**RE: Duke Energy Carolinas, LLC's and Duke Energy Progress, LLC's
Comments in Support of Inspections for Legacy Solar Generating
Facilities
Docket No. E-100, Sub 101**

2018/2019 Periodic Inspection Pilot Findings

Immediate Safety Issues – GOAB Pole

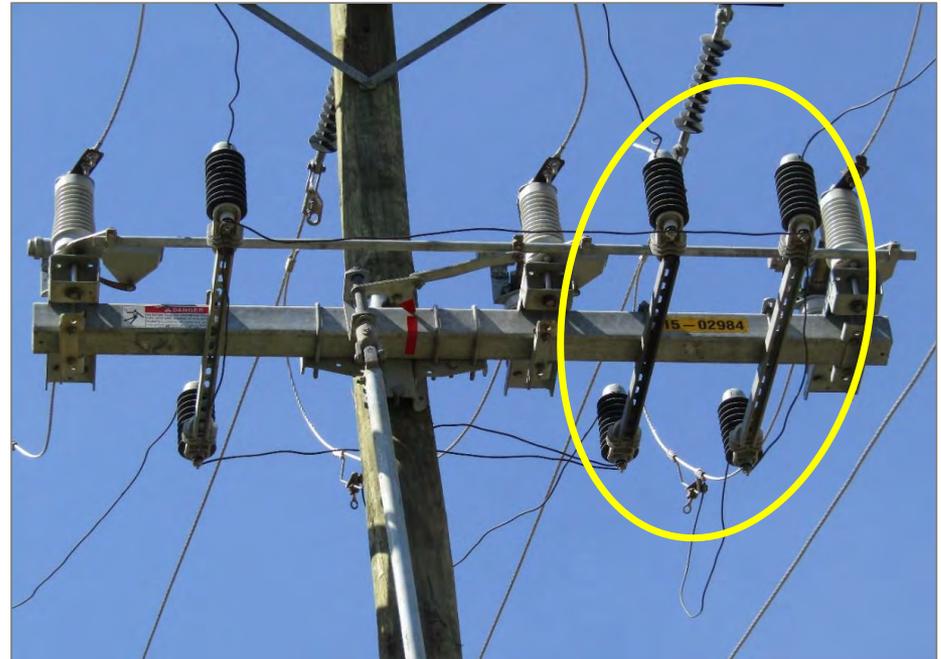
Control Rod Attachment

All GOAB handle and control rod brackets are very loose due to pole drying/shrinkage, lack of maintenance and lack of locking hardware, making the switch unsafe for operation.

NESC 012C, 120A and 121A; NEC 90.1(B), 110.3(B), 110.12 and 110.13; RUS 1728F-803 locknuts;
Duke 03.00-100D lockwashers

Ungrounded GOAB Switch Frame

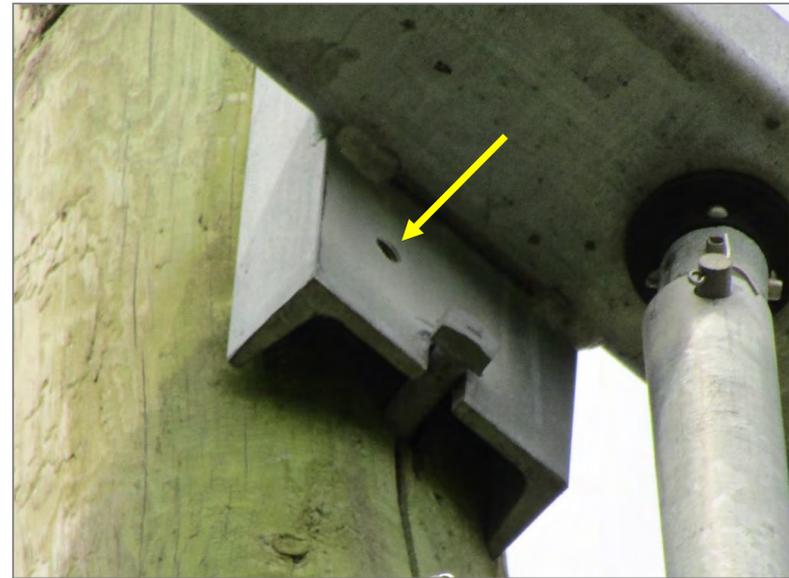
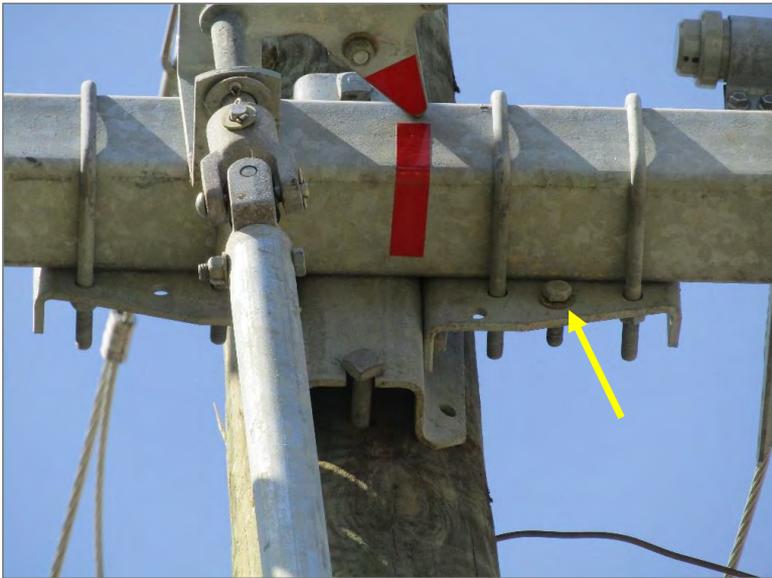
- Missing GOAB frame ground lug
- Missing 2 AWG solid copper jumper from GOAB frame to system neutral

Missing GOAB Switch Ground Grid

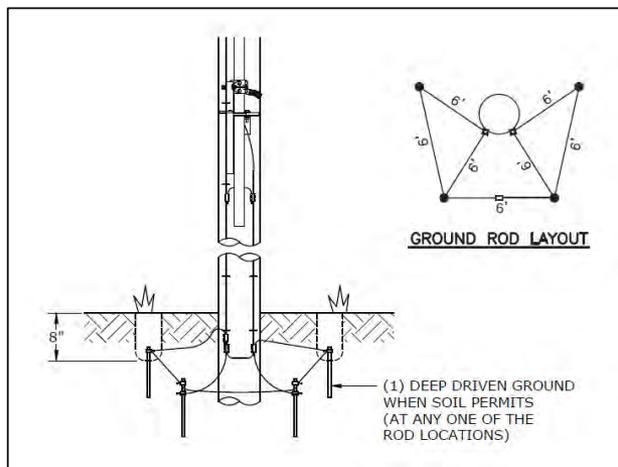
Control rod operated GOAB switches must have a ground grid equivalent to **one** of the following:

- Duke Energy (FMO) standard 08.10-37
- RUS Bulletin 1728F-804 drawing H3.1
- RUS Bulletin 1728F-804 drawing H4.1

GOAB Switch Ground Grid Options

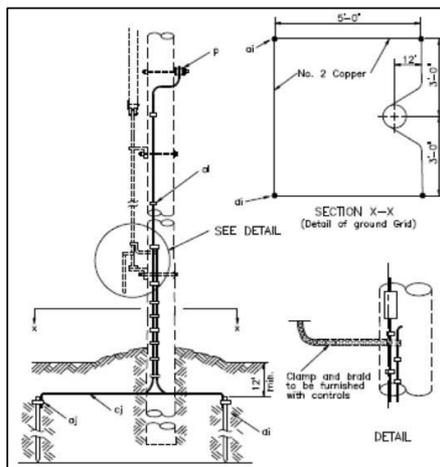
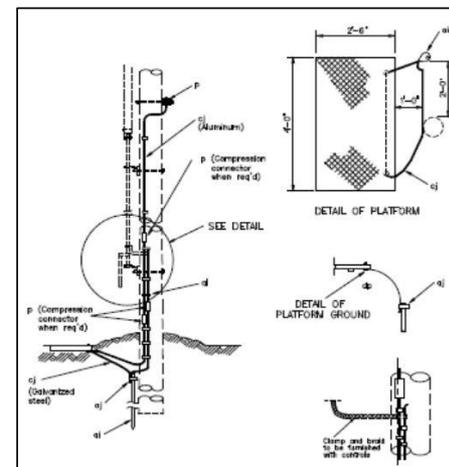
Duke Energy std. 08.10-37
four rods and 2 AWG solid
copper wire grid loop. One
20 ft. deep driven rod
required. Other three rods
8 ft. minimum

RUS Bulletin
1728F-804
drawing H3.1
four rods and 2
AWG solid
copper wire loop

RUS Bulletin 1728F-
804 drawing H4.1
galvanized steel
platform, one rod and
2 AWG solid copper
loop

Pole Ground Connection to Neutral

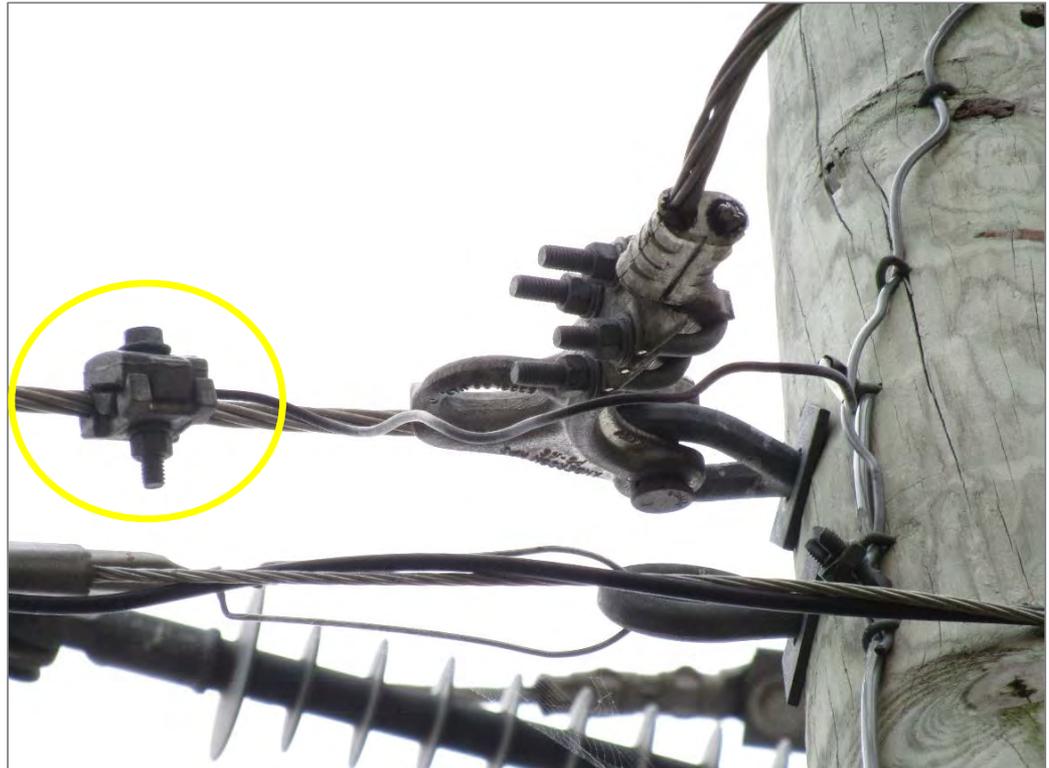
- Pole ground connection to system neutral using a mechanical connector
- A compression connector is required

Reliability & Power Quality Issues – GOAB Pole Vegetation Management

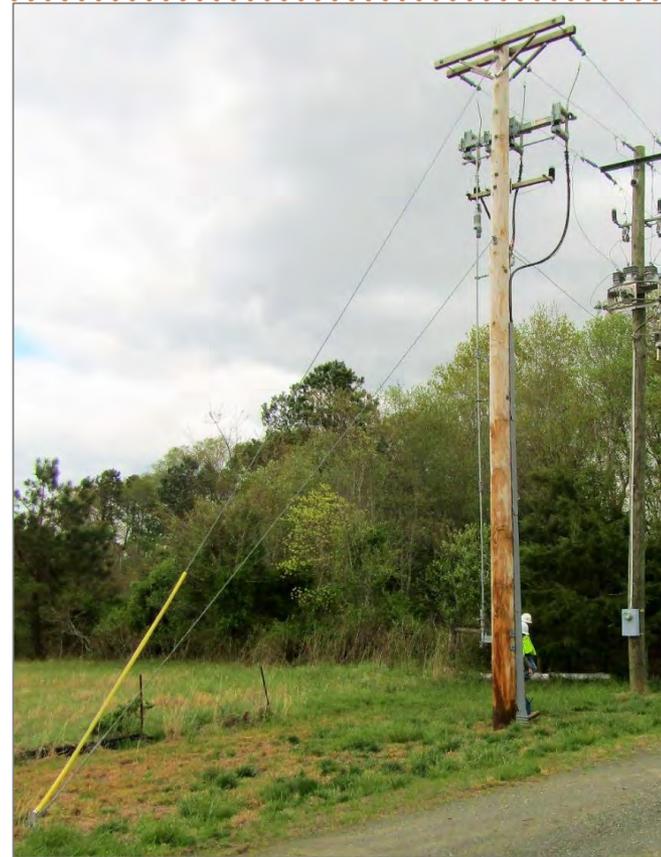
- Overgrown vegetation makes safe operation of the GOAB control rod difficult
- Overgrowth at this site concealed a cut GOAB pole ground conductor, making operation of the GOAB switch unsafe
- Overgrown deep ruts and large groundhog holes, making navigation at the point of interconnection dangerous

Insufficient Clearances

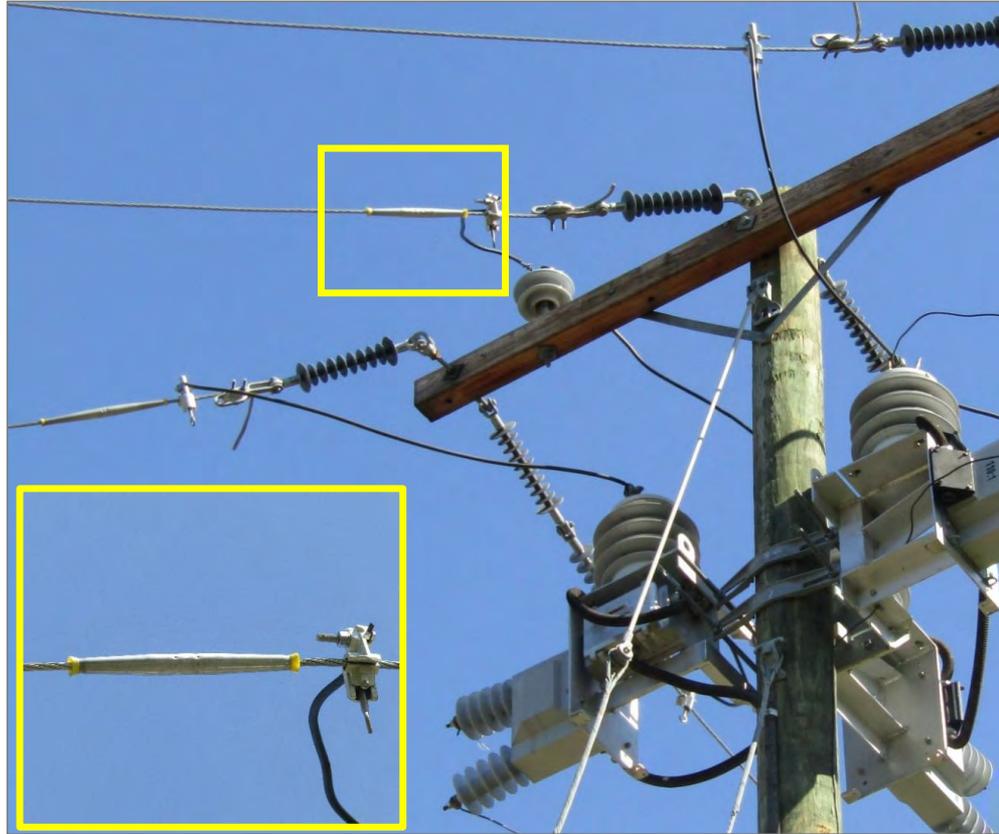
- 12 inches vertical phase-to-ground clearance where NESC requires 18 inches minimum
- System neutral and meter frame too close to crossarm results in congested meter pole framing with insufficient clearances

NESC Tables 235-1 and 235-5; DEC-DEM Distribution Standards Manual-Part 1 – 10003DUK and 88420DUK; Duke 06.00-120

Insufficient Switch Voltage Rating

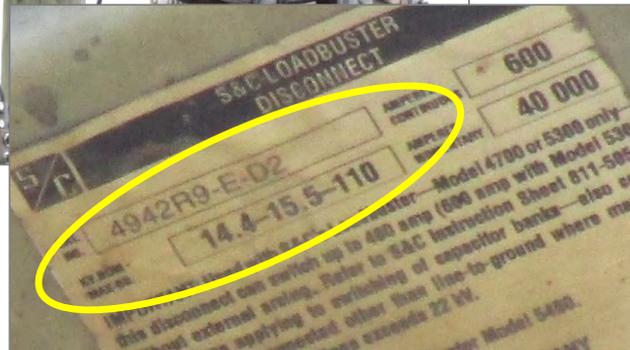
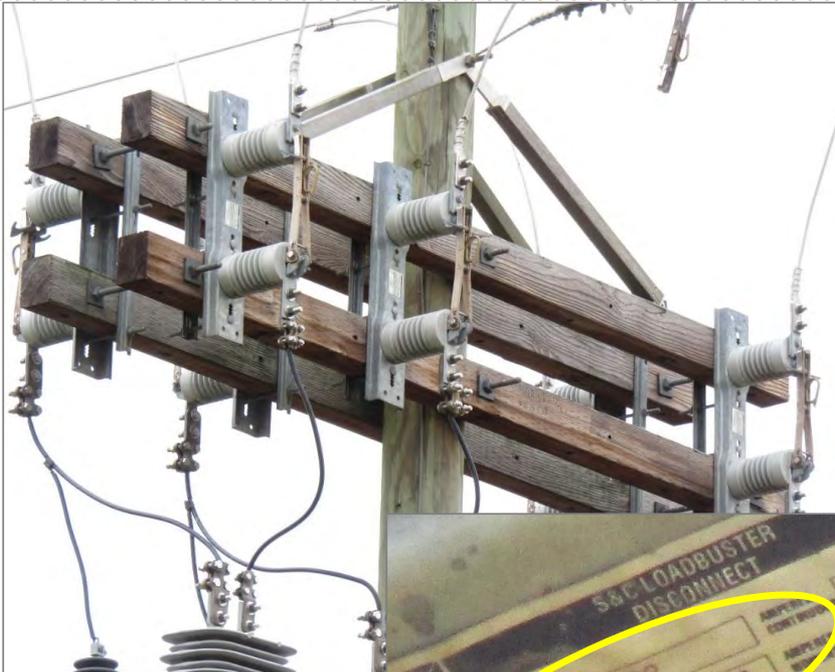
- 14.4 kV switches used where 27 kV switches are required for 23 kV nominal voltage
- 14.4 kV switches only have 110 kV BIL
- 125 BIL required for 23 kV system

Backwards Framed Meter Pole

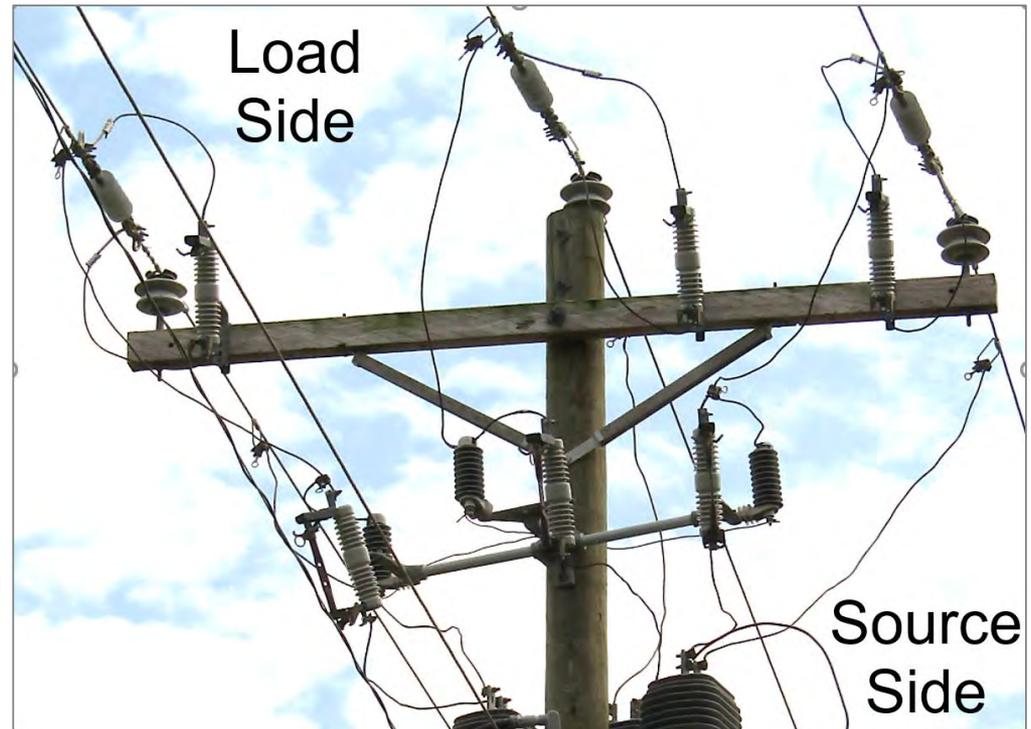
- Pole is built backwards so cutouts cannot be opened safely without first de-energizing the site
- Meter and bypass cutouts are reverse fed, with utility source connected to the bottom, causing the blades to remain energized when the switches are opened

Meter Field Wiring

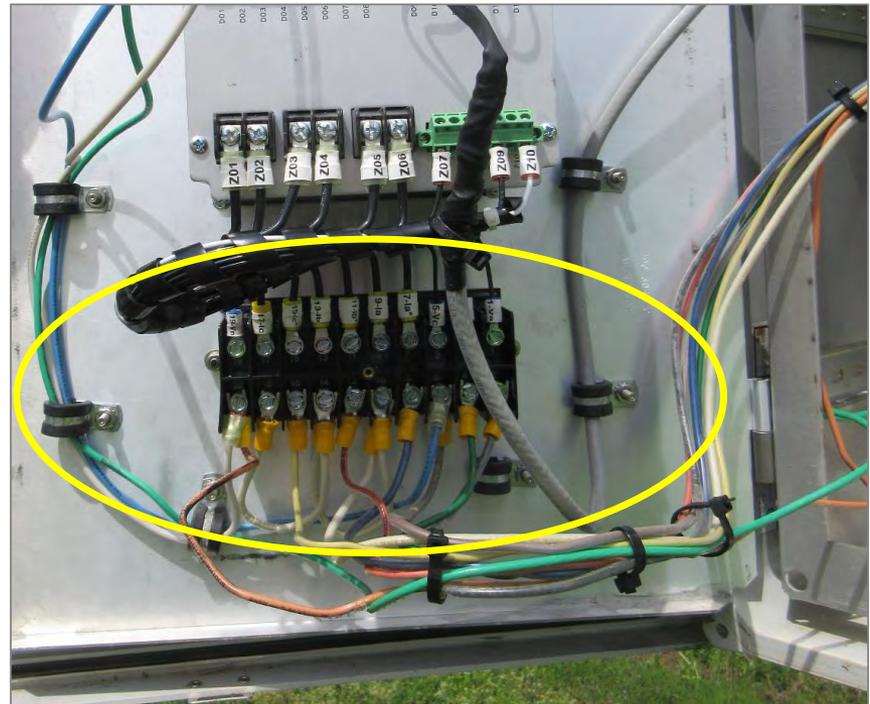
- 12 AWG solid copper field wiring used on hinged door mounted meter test switch
- All crimp-on fork terminals were loose on field installed solid wiring
- Crimp terminals are only listed for stranded wiring
- Several terminals came loose when door was opened due to stiff wire and loose connections
- Stranded wire is required for flex hinged door wiring

NEC 110.3(B), 110.14(A), 110.23 and 400.3

Meter Grounding

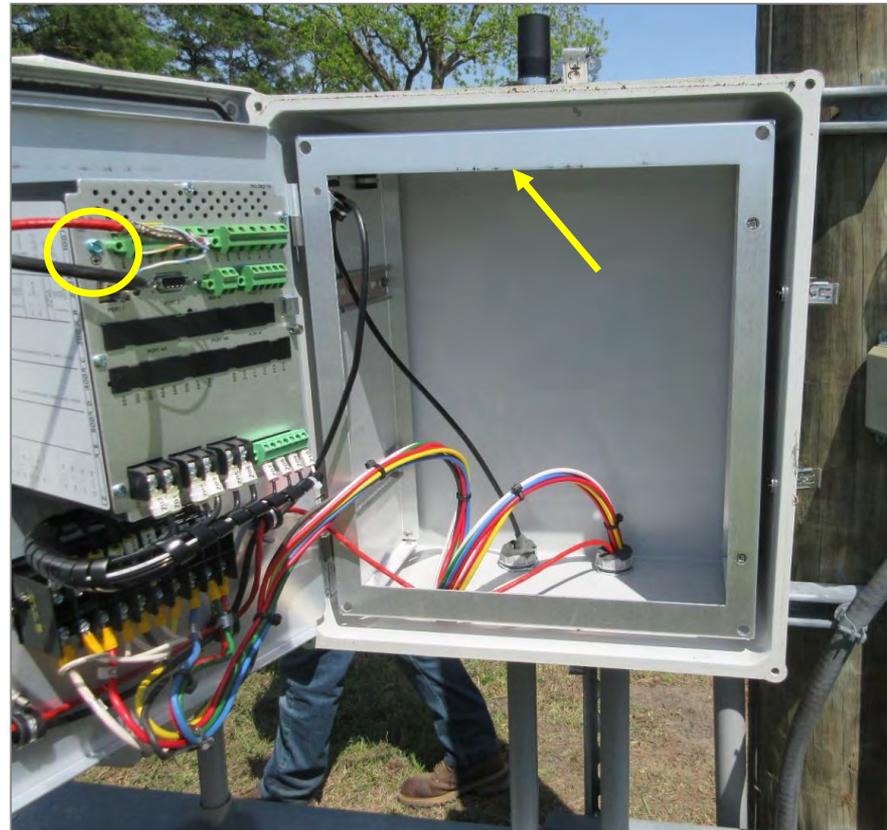
- Pole mounted aluminum meter enclosure not bonded to pole ground
- Meter chassis not grounded at green marked grounding screw

NESC 123A and 215C1; NEC 110.3(B), 250.4(A)(2) and 250.190; Duke 11.00-01, 02.03-110 and 20.04-143; RUS 1728F-803 Construction Specifications for Grounding

Insufficient Clearances

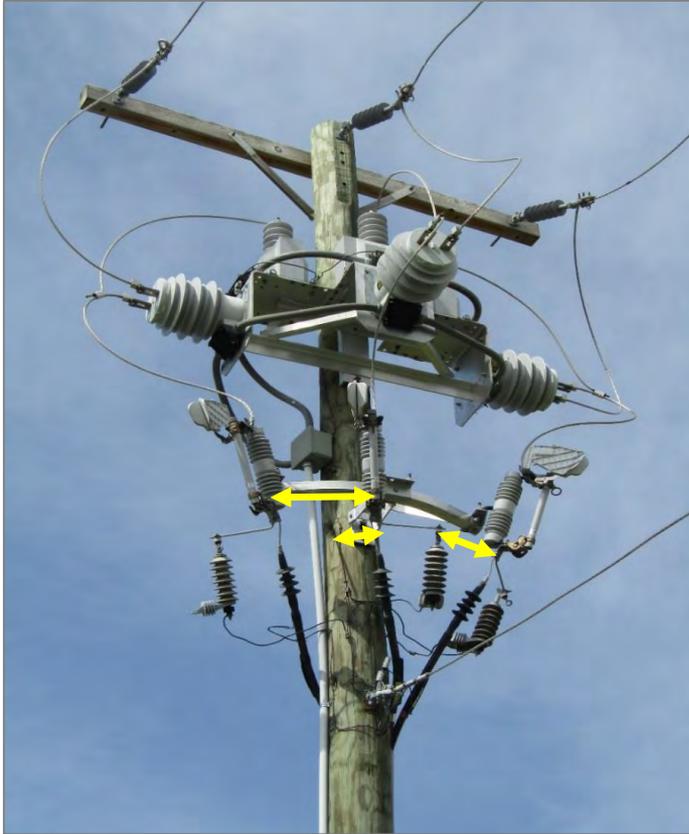
- Meter/riser pole with undersized 12 kV COLA bracket where 23 kV bracket is required
- Insufficient phase-to-ground clearance of 8 inches where NESC requires 14 inches min
- Insufficient phase-to-phase clearance of 12 inches where NESC requires 18 inches min

Undersized Terminator Braid Jumpers

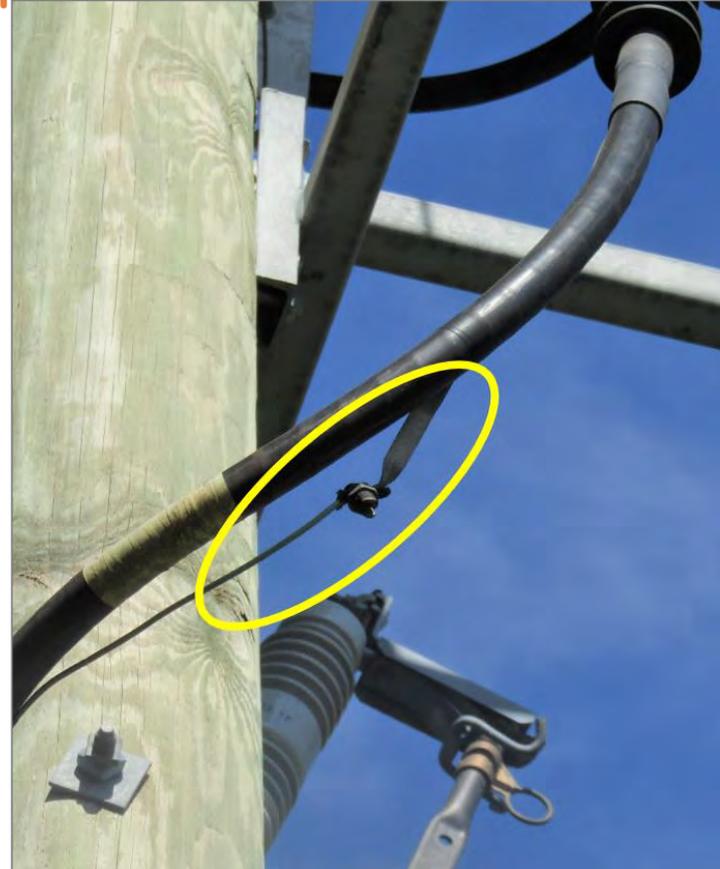
- The 10 AWG insulated copper ground jumper is undersized for the 6 AWG copper terminator ground braid
- The conductor must be equivalent in circular mils to the ground braid to be sufficient to carry neutral current

NEC 110.3(B) and 250.190(C); IEEE 576 section 14.2(h)

Undersized MV Cable

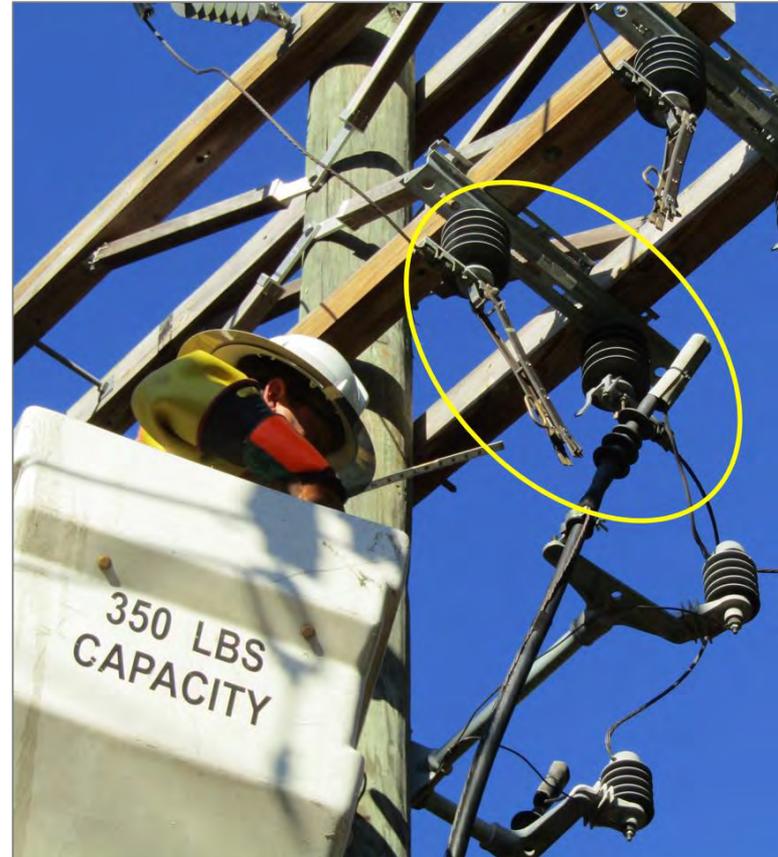
- Summer riser ampacity of 1/0 AWG AL MV cable is 160 Amps
- Facility rated current is 232 Amps

Insufficient Clearances

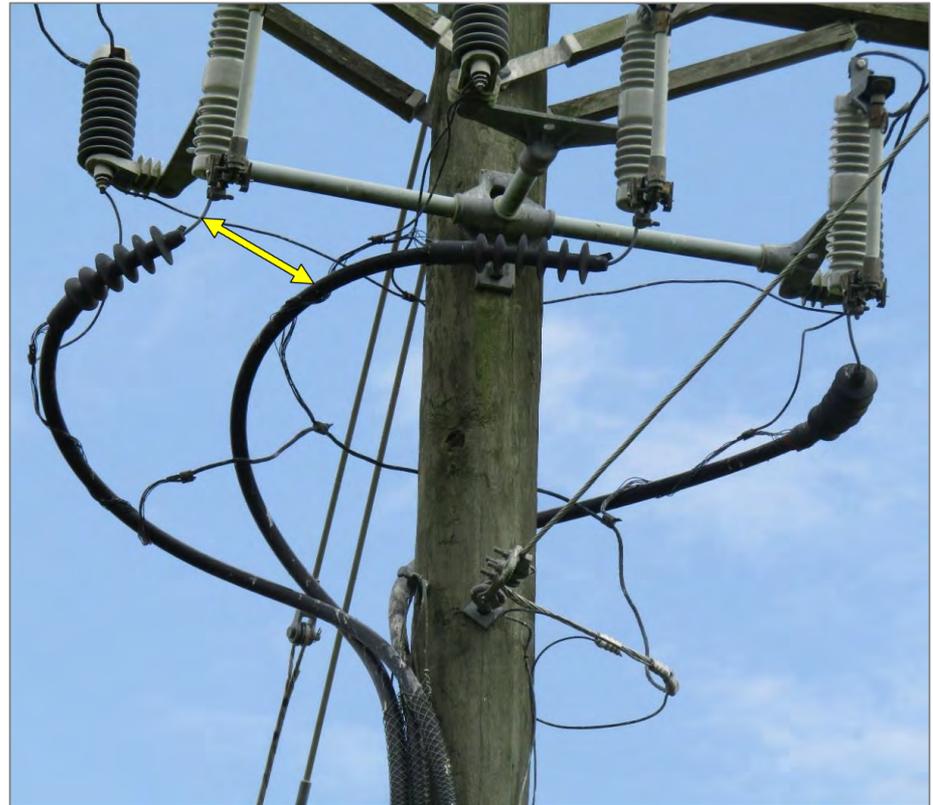
- Arrester ground leads too close to MV cable terminations of opposite phase
- 8 inches of phase-to-ground clearance where NESC requires 14 inches minimum
